Notice of Modification

Section 75W of the *Environmental Planning and Assessment Act 1979*

06_0239

Eastern Creek Waste Project.

APPENDIX 1 – Site Plan

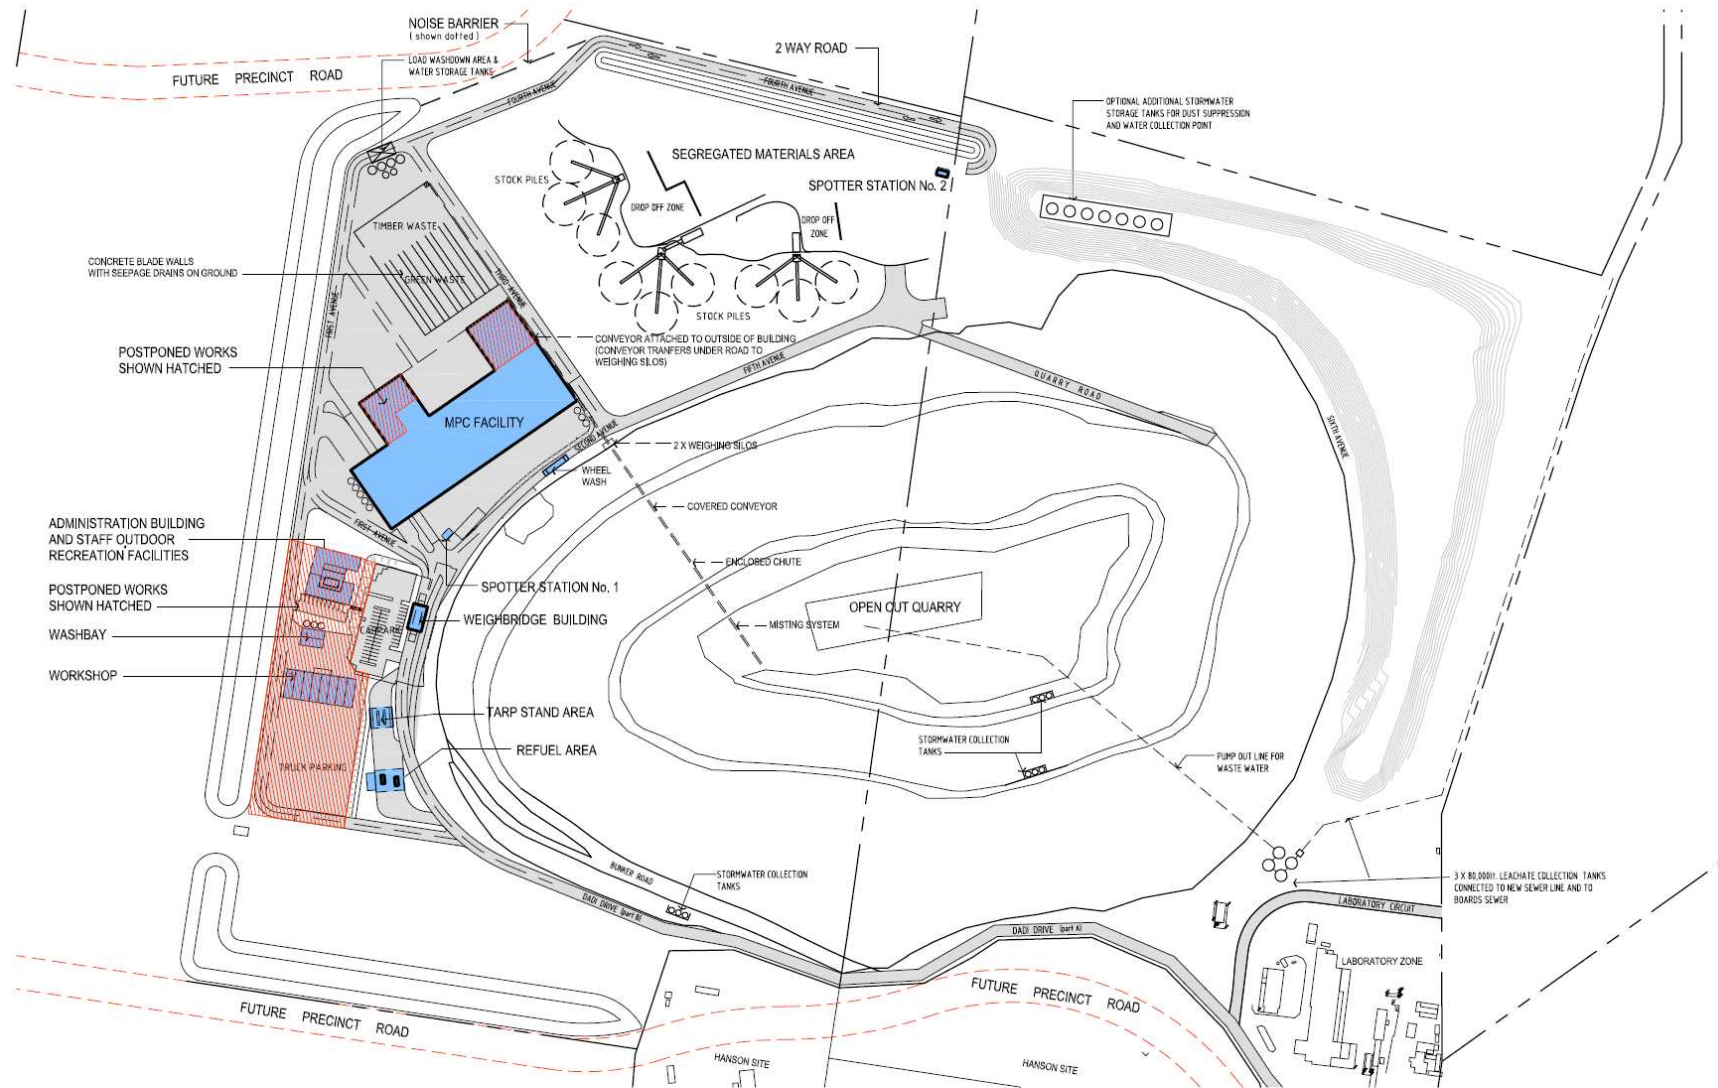
11. Replacing existing Site Plan in Appendix 1 with new Site Pan.
